Air
Controls
Products

Service Bulletin 406K Retro-Kit

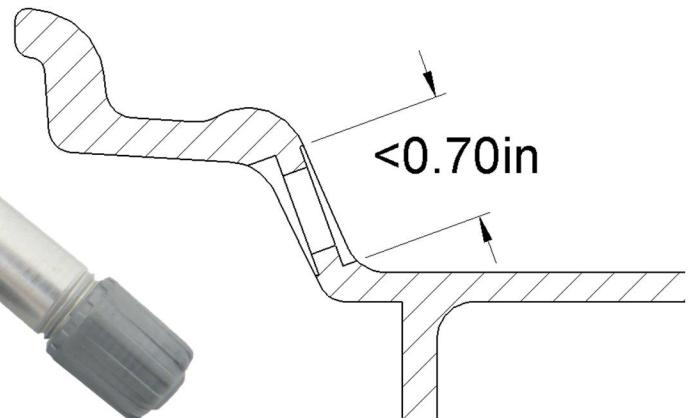
The washer diameter on 7002A is 0.70in. Certain OE wheels have a valve hole counterbore diameter smaller than 0.70in. Retro-fit 7002A with 406K and install nut to 71 in-lbs.

- 1.) Check counterbore diameter. If a US dime coin does not fit, 406K is needed.**
- 2.) Remove the washer and grommet from 7002A and install 406K parts.**
